TRANS/WP.29/781

DRAFT SUPPLEMENT 4 TO REGULATION No. 50

(Position, stop and direction indicator lamps for motorcycles)

"Front position lamps (for a pair of lamps)

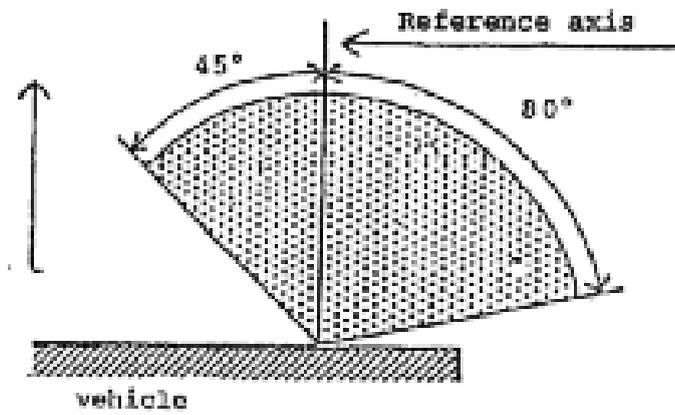
Paragraph 1., insert a new figure to read:

$V = +15^\circ / -10^\circ$

"Rear position lamps (for a pair of lamps)

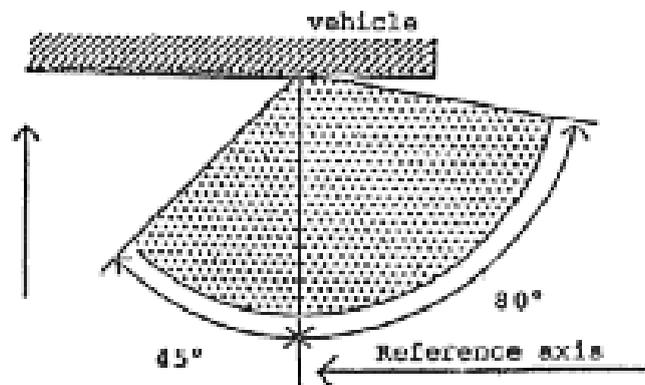
Paragraph 2., insert a new figure, to read:

$V = +15^\circ / -10^\circ$

"3. Direction indicators of categories 11, 11a, 11b, 11c and 12

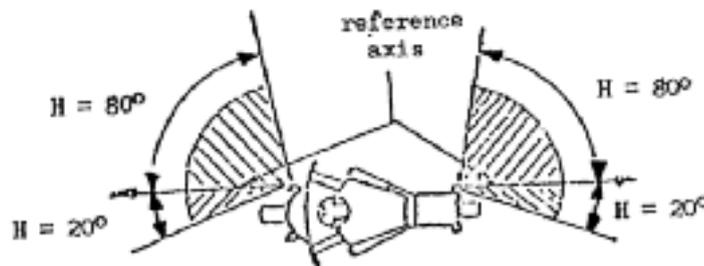
Paragraph 3., amend to read:

$$V = \pm 15E$$

Minimum horizontal angles of light distribution in space:

Categories 11, 11a, 11b and 11c: direction indicators for the front of the vehicle;

Category 11: for use at a distance not less than 75 mm from the passing beam headlamp;

Category 11a: for use at a distance not less than 40 mm from the passing beam headlamp;

Category 11b: for use at a distance not less than 20 mm from the passing beam headlamp;

Category 11c: for use at a distance less than 20 mm from the passing beam headlamp.
